Access Compliance Report

Public Rights-of-Way

(Curb Ramps)

| Intersection ID: 52249 | Main Street: PARK_RD | Cross Street: N/A | Location: W |

| ADA ID: FE3BF129D83A | Ramp Type: BlendTrans1 | Initial Pass/Fail: Fail | Overall Compliance: No |

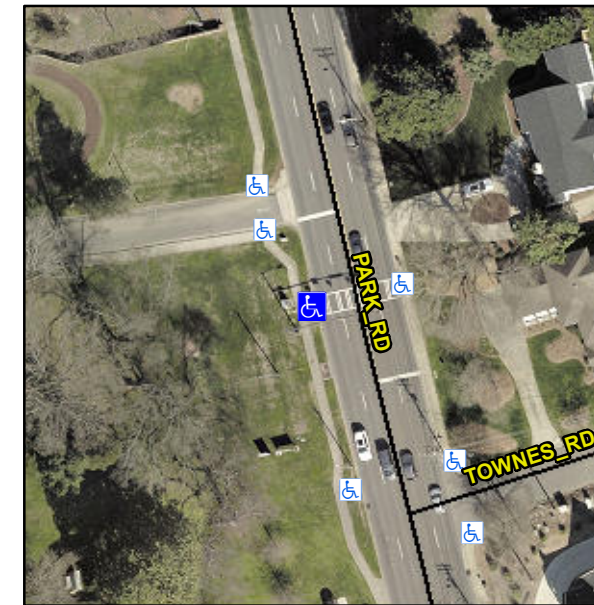
R304.5.1, R304.5.3

| Compliance | Description | Data | Compliance | Description | Data |
|------------|-----------------------|-------|------------|-----------------------------|------|
| No | Ramp Width (in) | 47.0 | No | BlendTrans XSlope (%) | 2.6 |

Remove & Replace Curb Ramp With Two New Directional Ramps or Equivalent.
